FLAP RAC CONTROL

SLAT RAC CONTROL

S/N 029

FSECU J92C1 KEYED AT A PINS

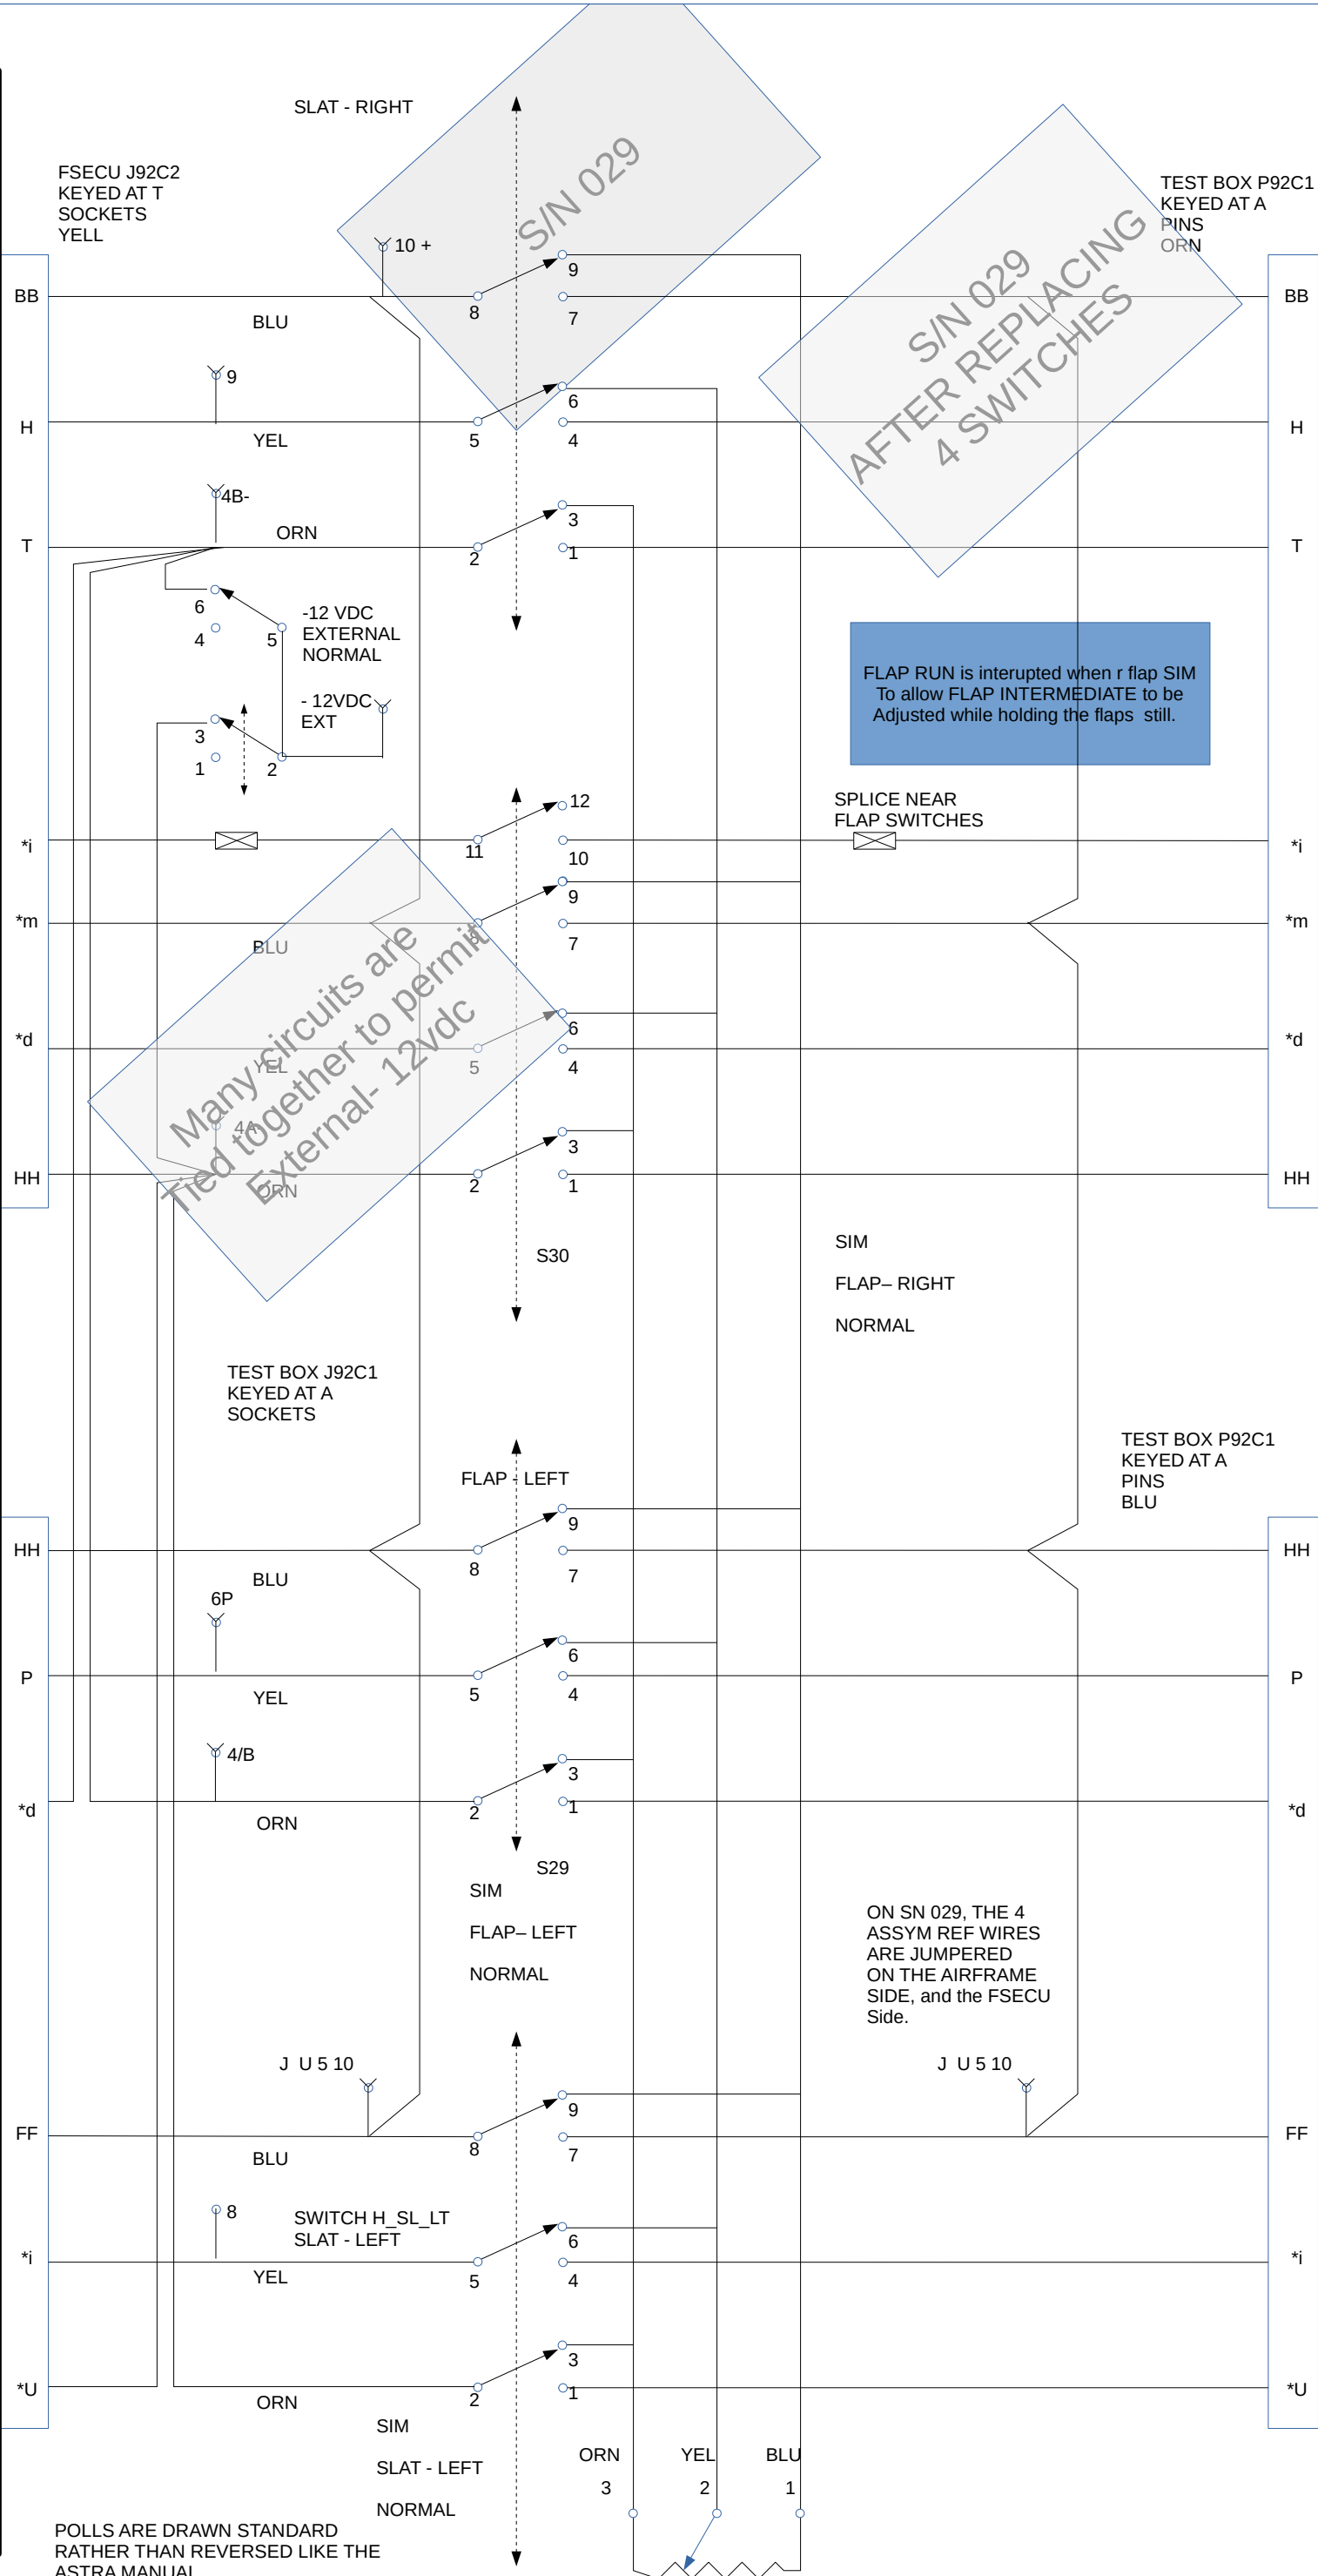
POLLS ARE DRAWN STANDARD RATHER THAN REVERSED LIKE THE ASTRA MANUAL.

Also, FSECU is drawn on the left here , it is on the right in the original

C1

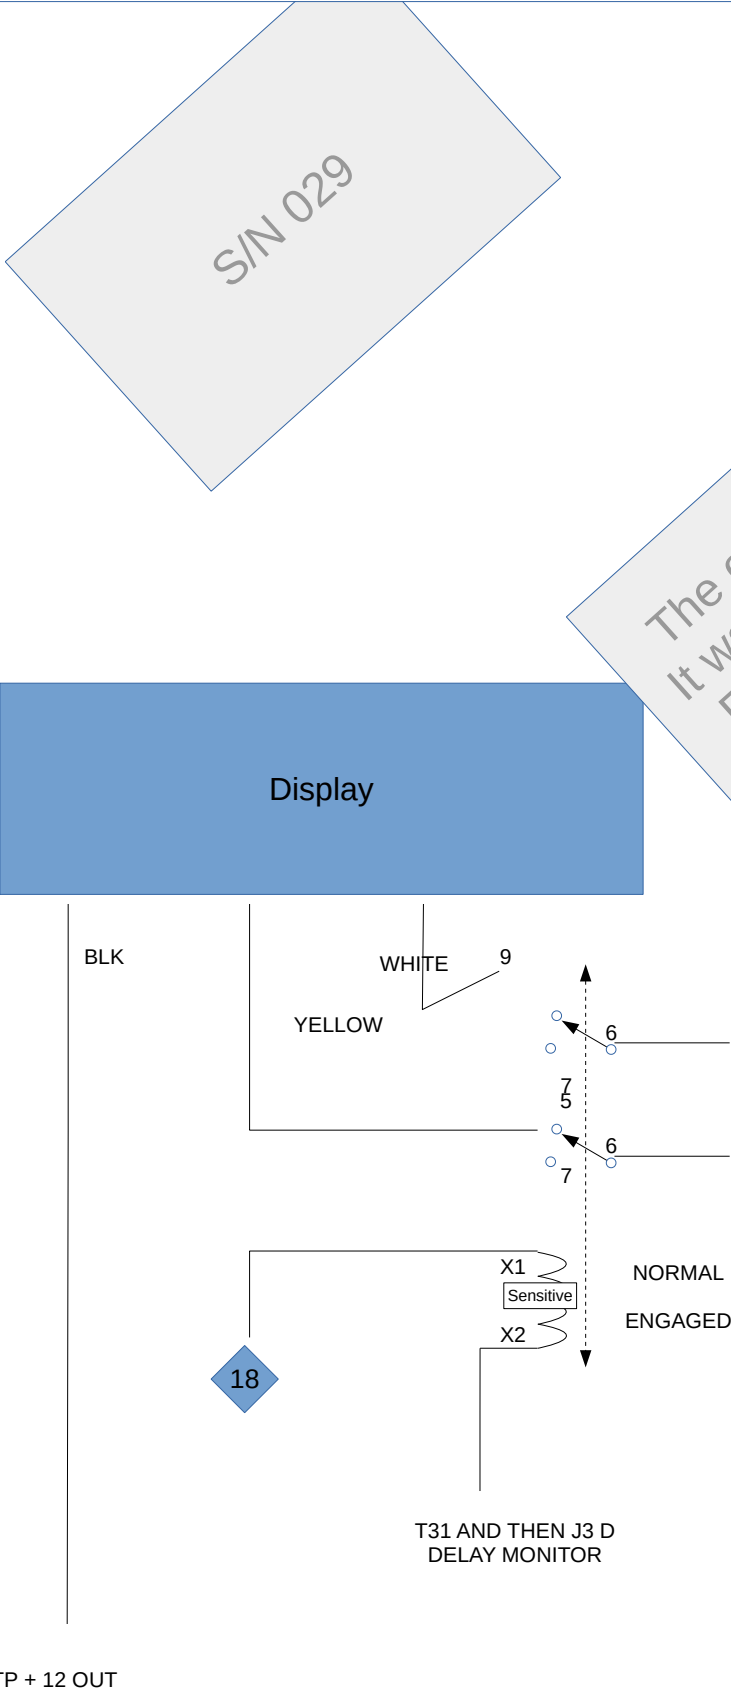
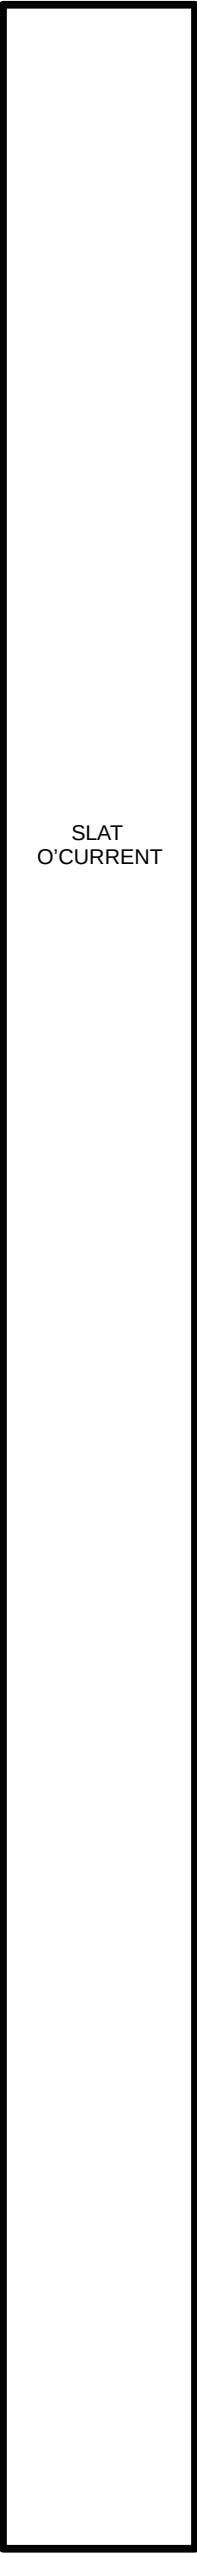
The old display is deprecated.
It watched C3- pin D for FSECU
FAULT TIMING. 1.25 seconds

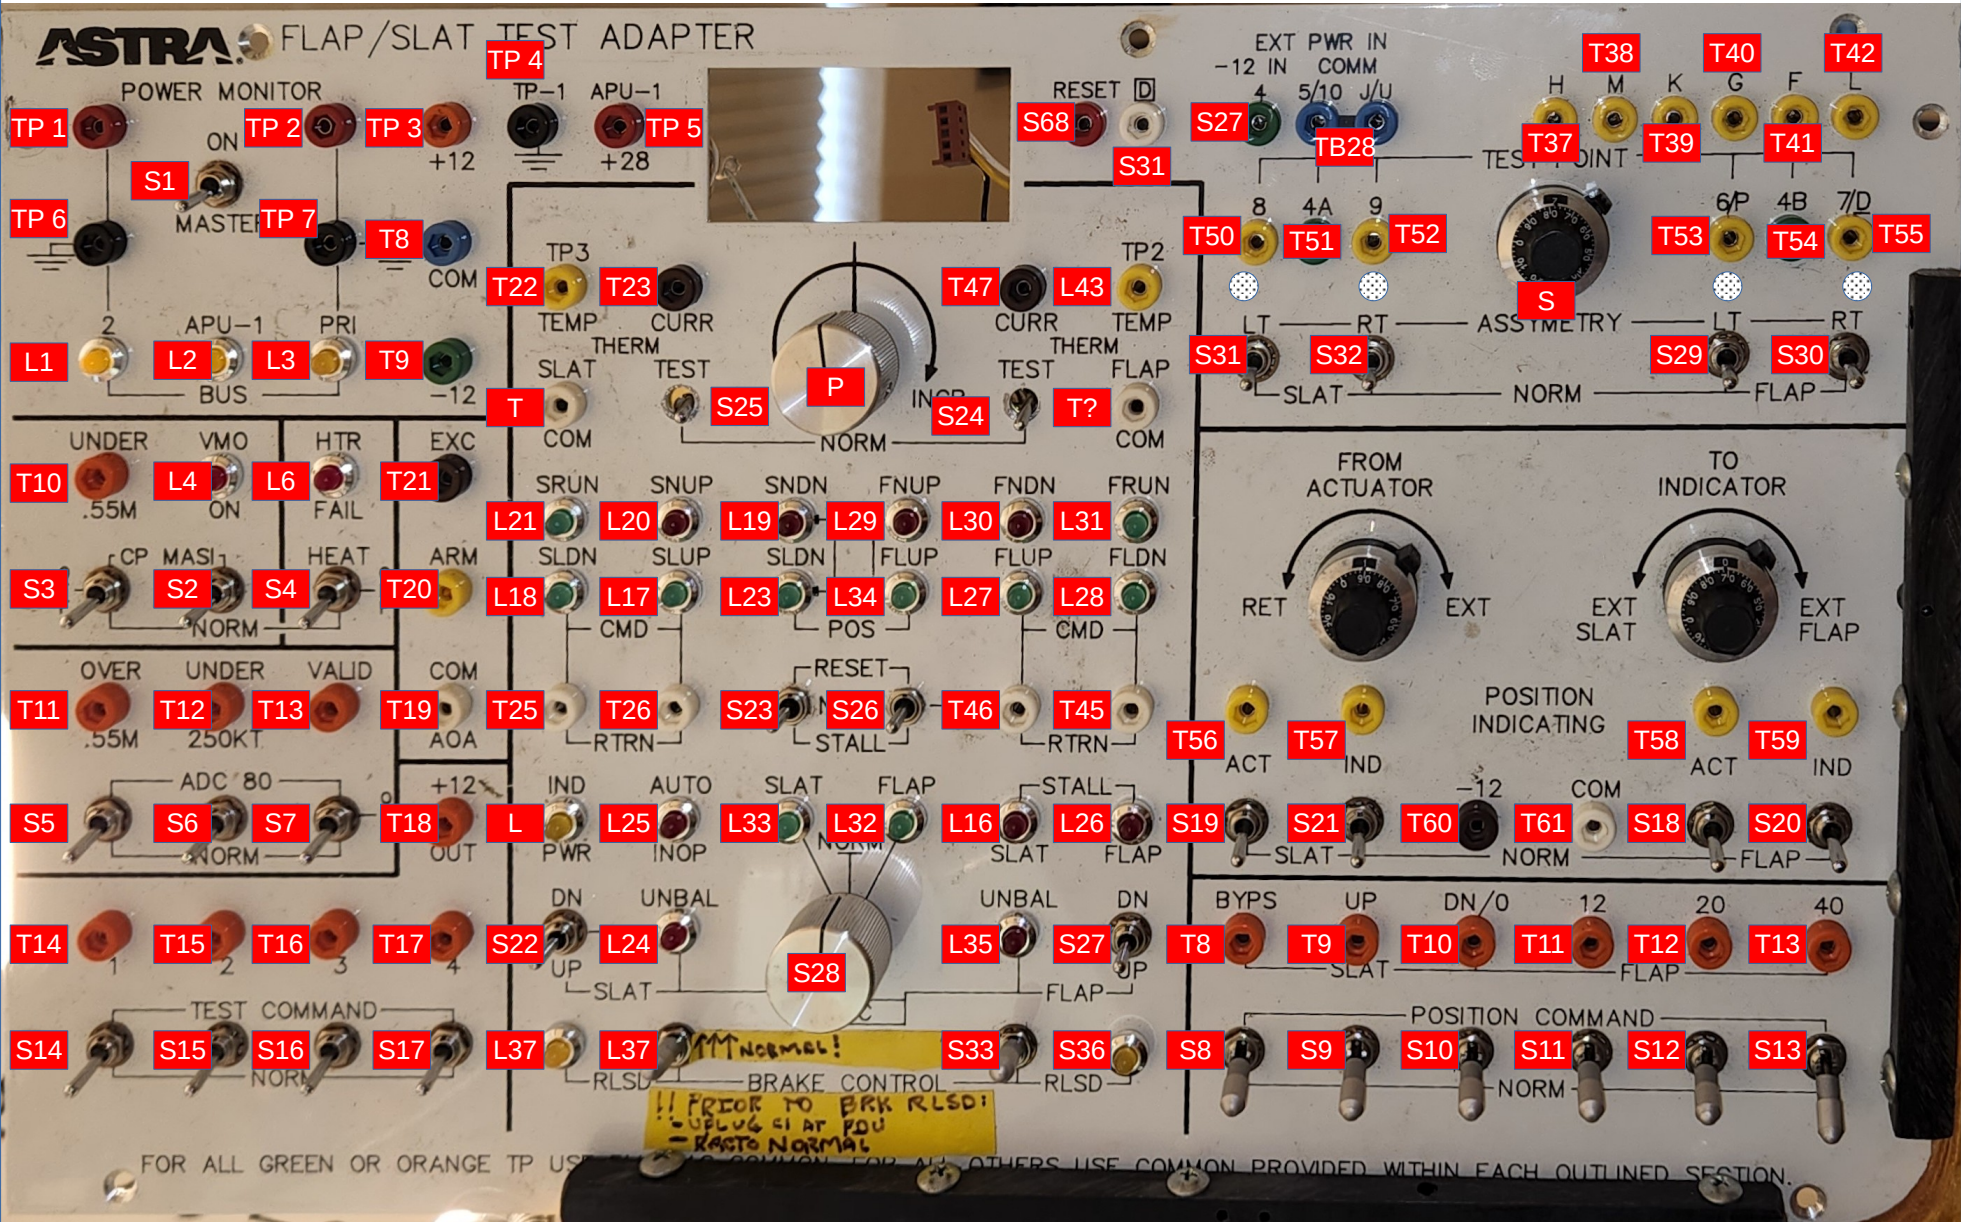
s1	0.003	
s2		
s3		loose
s4	0.004	
s5	2	
s6	2	
s7	2.5	
s8	0.02	
s9	0.05	
s10	0.2	
s11	0.029	
s12		
s13	0.5	loose

Substituted with 3 position switch

s18	1.5	
s19	0.008	
s20	.25	
s21	0.008	
s22	0.004	
s23	0.073	
s24	.039	
s25	0.109	
s27	0.004	
s28	0.027	upper terminal erratic
s29	0.055	
s31	0.066	
s32	0.125	
s33	0.002	
s34	0.002
